PLANNING DEPARTMENT STAFF REPORT AND FINDINGS

ROLLING MEADOWS MINOR PARTITION – PRELIMINARY PARTITION APPROVAL (File MP 23–17)

Preliminary Partition Plan Map

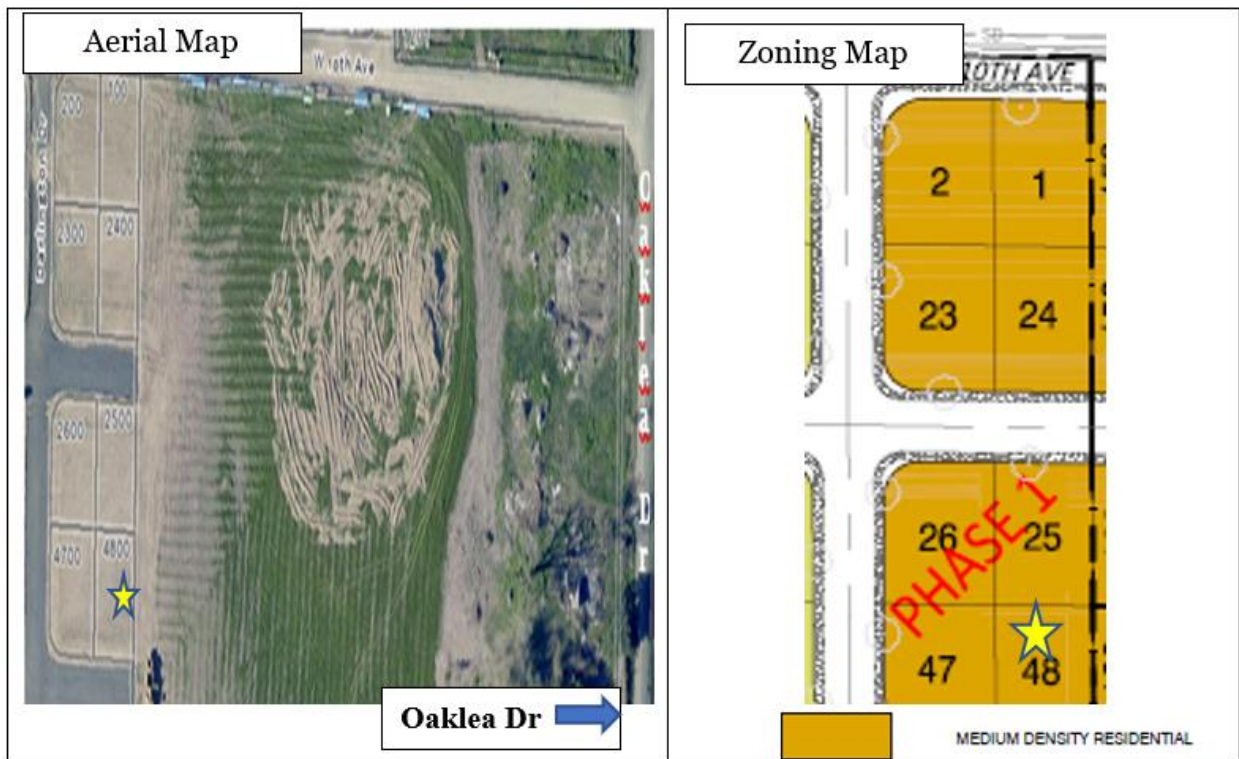
The 34+ foot lot widths of the proposed minor partitions do not meet the existing minimum width standard of 50 feet of 17.15.030.E. However, the applicant has proposed a major modification to the PUD (PUD 23–24) that would reduce the minimum lot size to 3,000 square feet, increase the minimum lot depth to 90 feet, and reduce the minimum lot width to 34 feet. If this modification is not first approved by the Planning Commission then this minor partition cannot be approved.

Finding 9: The preliminary plan has the date, north point and scale of the drawing. The demensions of the property are adequately identified as adjacent tax lots are identified and numberd. The legal description of the property is Lot 48, Rolling Meadows PUD Phase 1. Neither the preliminary partition plan nor the supplemental materials identify the assessor's account number (Act #1914516).

Finding 10: The name and address of the owner/partitioner is present on the preliminary plan and its telephone number. However, the telephone number is included on the application form. The applicant's representative's name and address is listed on the preliminary plan as is Marcus Cross, the applicant's surveyor.

Finding 33: The preliminary plan shows a 5' x 15' water easement, a 5' x 7.5' water easement and a public utility easement; all dedicated to the city.

Finding 39: The proposed parcels are large enough for their intended residential use for attached single-family dwellings. However, because the lot widths are actually slightly less than 34 feet on 9th Avenue, it is recommended that the parcels share a driveway when developed.

Condition of Approval #1: The final plat must show all easements. All easements must be recorded and the public utility easements dedicated to the City prior to final plat approval.

Condition of Approval #2: Because of the narrow width of the lots, the parcels must have a shared driveway when developed.
